Proposals for amendments to annexes A and B of ADR:

Construction and approval of vehicles

Section 9.7.6 – Rear protection of vehicles

Transmitted by the Government of France*

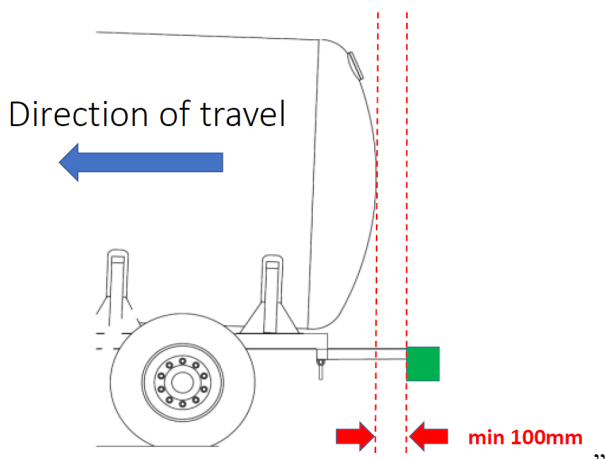
10. Amend the first two sentences of 9.7.6 to read as follows:

“A bumper sufficiently resistant to rear impact shall be fitted over the full width of the tank at the rear of the tank-vehicle. There shall be a clearance of at least 100 mm between the rear of the tank (or of its projecting fittings in contact with the substance being carried) and the face of the bumper facing the rear wall of the tank. This clearance shall be measured as specified in the figure below:
